REVISED

ENVIRONMENTAL IMPACT STATEMENT

PROPOSED ALII LANDING

CLUSTER DEVELOPMENT

FIGURE 6 OFF-SITE SEWER PLAN

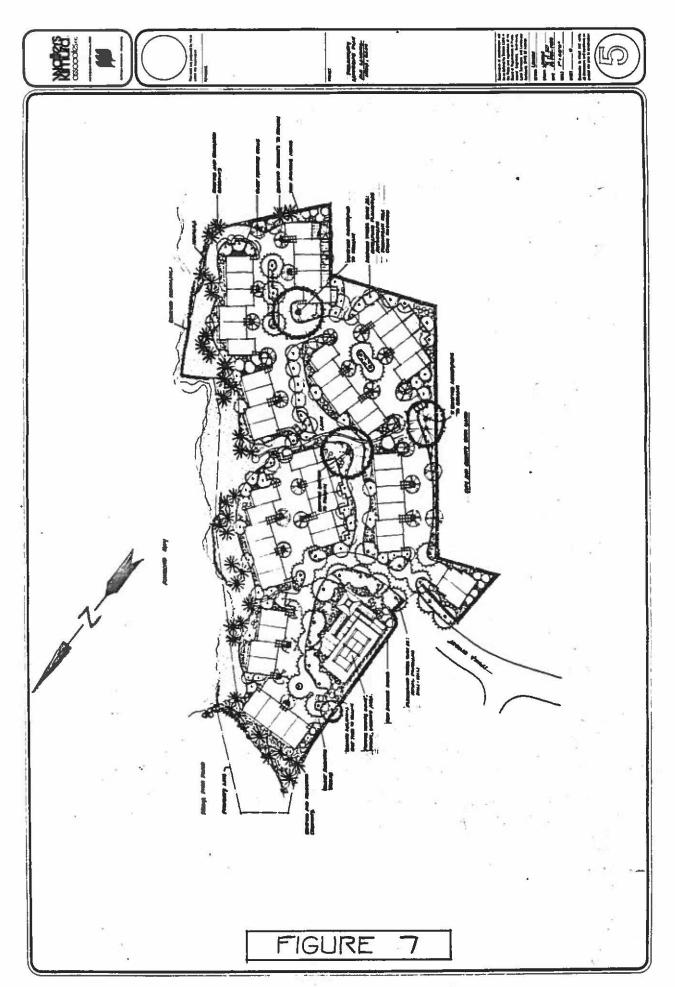
- The proposed off-site sewer plan (Figure 6) is not acceptable. The plan that has been tentatively approved by the Division of Wastewater Management consists of a private force main that will be connected directly to the 27-inch Heeia interceptor sewer on Kamehameha Highway. Connection to the existing 6 and 8-inch force mains will not be permitted.

- 3. During the construction phase, the grading operation will be done with adequate erosion control measures to prevent silt and other undesirable matter from entering Kaneohe Bay. Sediment basins will be sized and located throughout the site such that water quality into Kaneohe Bay is not affected. Filter berms will be constructed along the entire ocean frontage. A temporary erosion control plan will be subject to review and approval by the City and County of Honolulu prior to any construction.
- 4. A 4-inch force main will run through the project site and along Ipuka Street to Kamehameha Highway where a connection to the 27-inch Heeia interceptor sewer is proposed. This entire system up to the sewer connection will be maintained by the Alii Landings Homeowner's Association. Figure 6 (off-site sewer plan) illustrates the proposed sewer system.
